Subject: Oconee Nuclear Station  
Docket Numbers 50-269, -270, -287  
UFSAR Chapter 15 Transient Analysis Methodology,  
Topical Report DPC-NE-3005-P, Revision 1

Responses to Request For Additional Information  
DPC-NE-3005P Revision 1

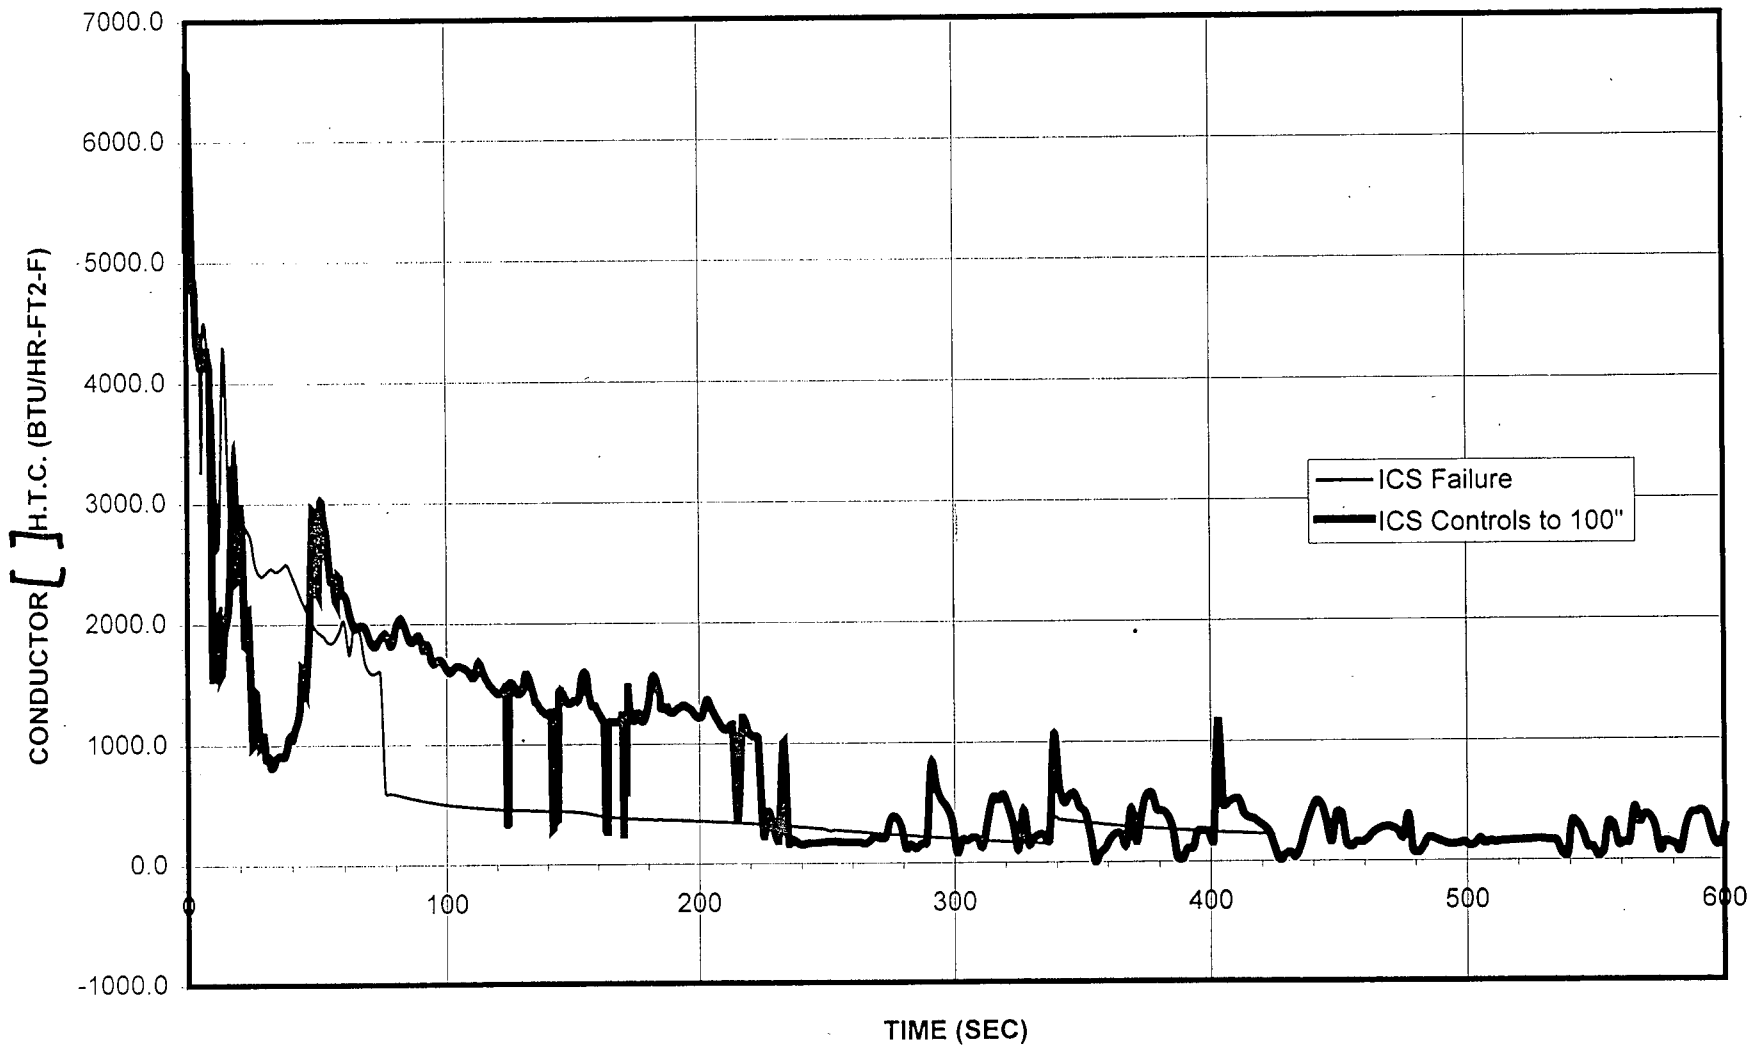
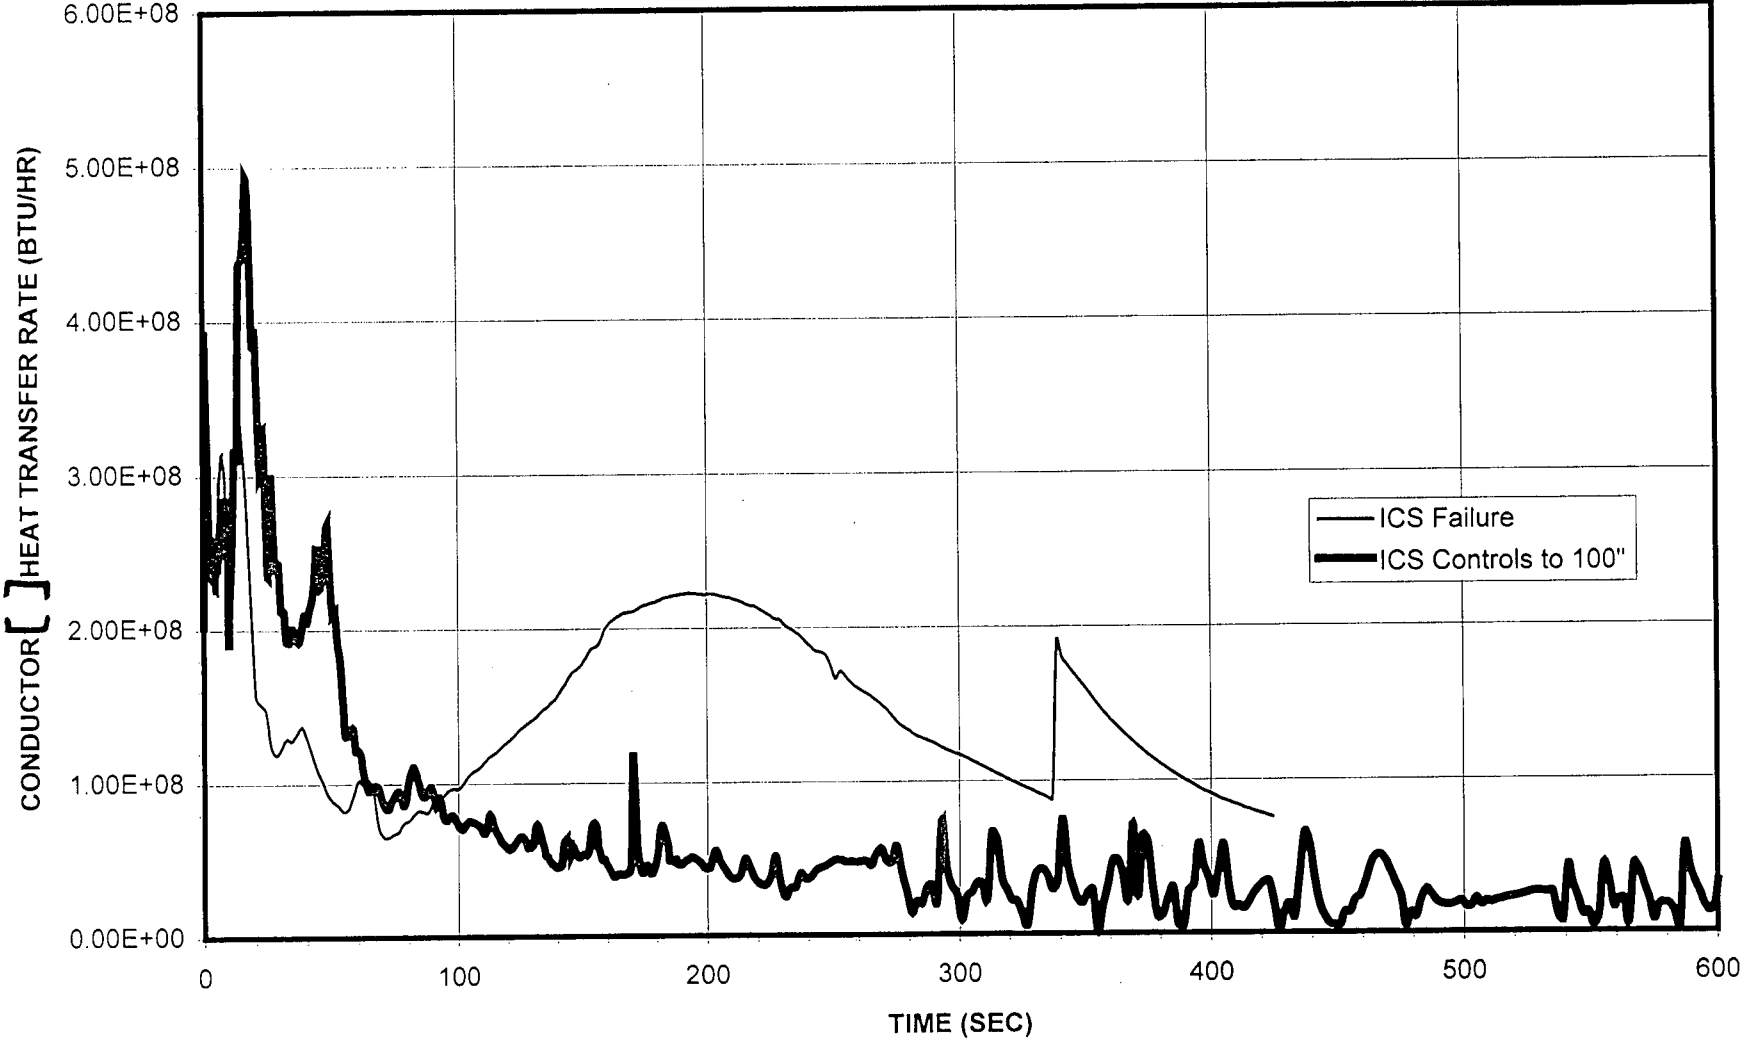
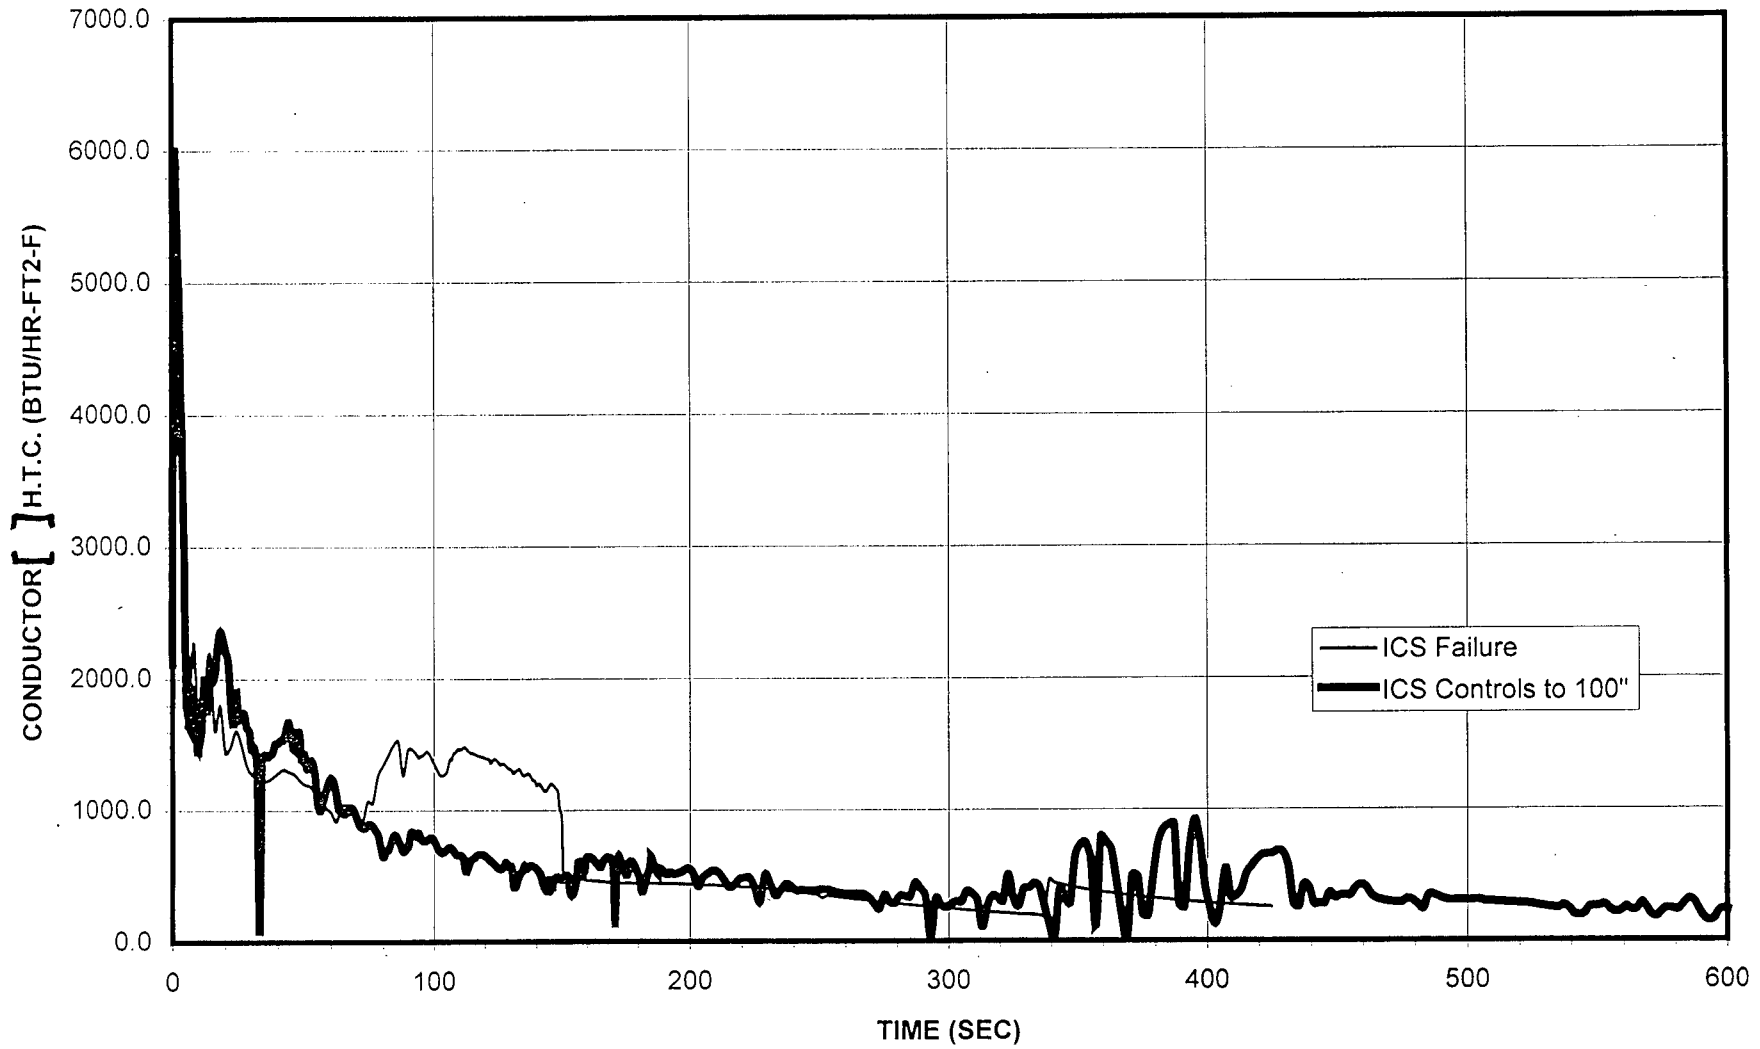
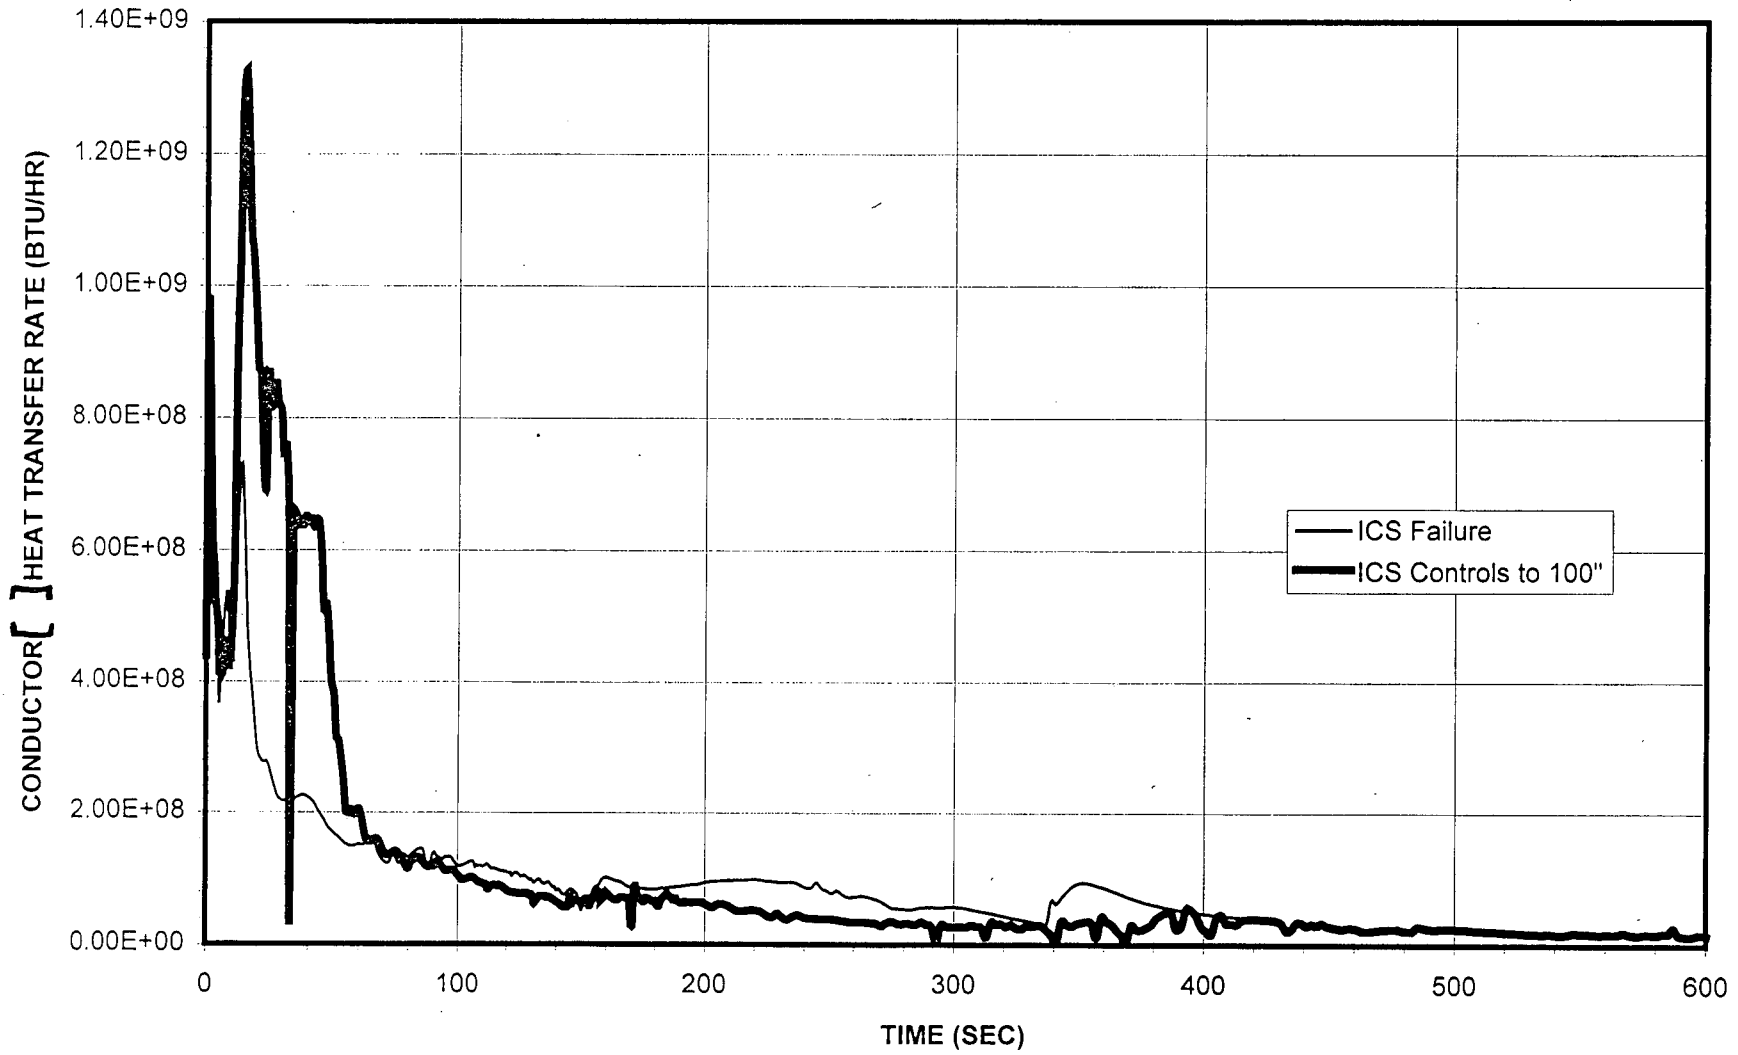
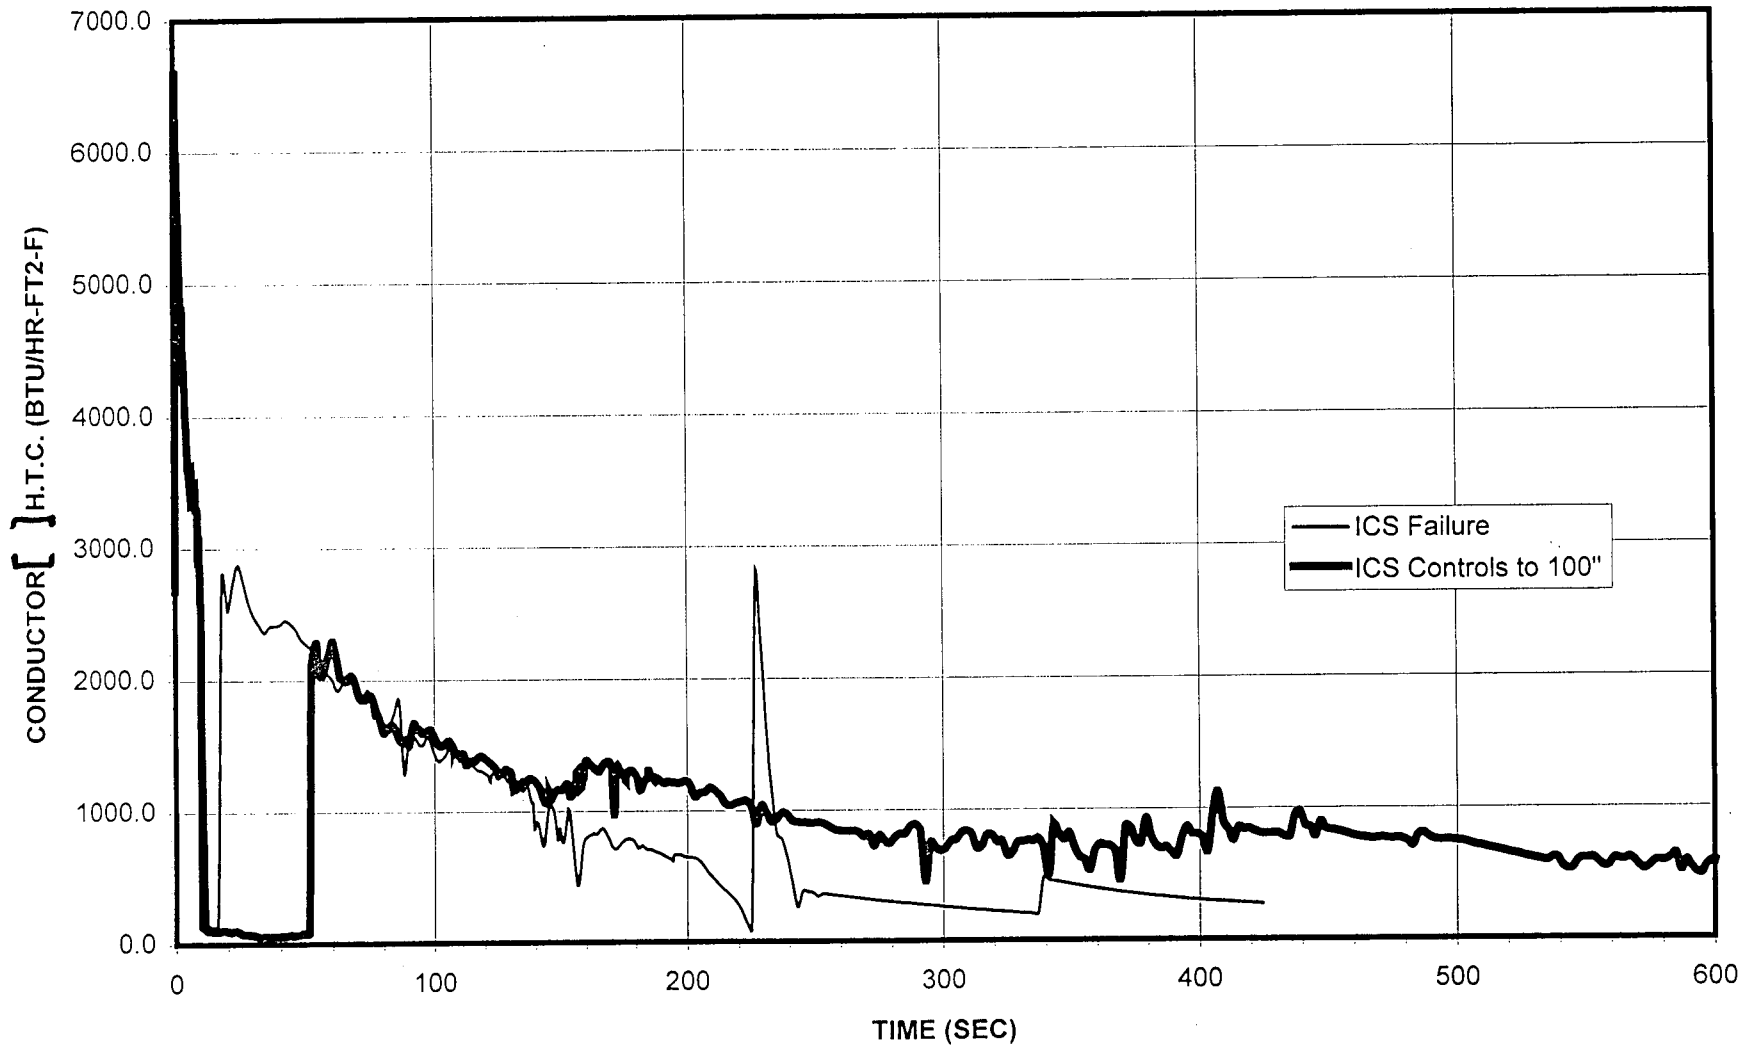
- Q6. Page 15-14 states that the limiting assumption with respect to maximizing overcooling and reactivity addition has been determined by analysis to be the case when the Integrated Control System (ICS) is controlling main feedwater. This case was found to cause more overcooling than the case that assumes failure of the ICS, which would permit unlimited main feedwater addition to the affected steam generator. Provide comparisons of the conditions within the affected steam generator secondary that would cause the ICS operating case to be the worst case. Compare steam generator level, pressure, temperature, and heat transfer coefficients that are calculated by the RETRAN code.

Figures 7-16 show the heat transfer coefficient and the heat transfer rate for [ ] steam generator tube conductors. The [ ] were selected to show the axial variation in the predictions. The elevation and height of each conductor above the lower tubesheet are as follows:

Under full power steady-state conditions, the SG tube bundle heat conductors exhibit well defined heat transfer modes. The lower bundle region (Conductors [ ]) contains a relatively large amount of liquid, and is in the nucleate boiling heat transfer mode. The middle bundle region (Conductors [ ]) contains a larger ratio of steam to liquid, and is in the forced convection vaporization heat transfer mode. The upper bundle region (Conductors [ ]) contains steam and is in the forced convection to superheated vapor heat transfer mode. During the blowdown phase of the MSLB, conditions within the SG undergo a violent change. The decompression of the steam generator causes liquid in the lower region of the tube bundle and in the downcomer to be transported to higher elevations within the tube bundle by entrainment in the high velocity steam flow. Due to the severe pressure reduction, flashing occurs in the downcomer and results in reverse flow through the aspirator port. The reverse aspirator port flow contributes to a second boiling region in the upper tube bundle. Upper tube bundle conductors, which are at the hottest temperatures, are

periodically quenched with slugs of entrained liquid. For the ICS failure case, the SG gradually fills with liquid after the initial blowdown and experiences less boiling. The accumulation of subcooled liquid as the overfill progresses results in RETRAN predicting the forced convection to subcooled liquid heat transfer mode. For the ICS controlling to 100 inches case, MFW flow is unstable as the ICS attempts to maintain the level setpoint. During periods of high MFW flowrates the liquid levels within the tube bundle increase, causing heat transfer behavior similar to the initial blowdown. During periods of low MFW flowrates, the hotter tube bundle regions dry out. As the temperature differences between the primary and secondary decrease as the analysis progresses, heat transfer coefficients and rates decrease for all conductors for both cases. The integral effect of the heat transfer predicted for each tube bundle conductor is described in the preceding paragraphs. The overall heat transfer rate, and therefore the consequences of the two MSLB cases are quite similar, with the case with ICS controlling to the level setpoint slightly more limiting.
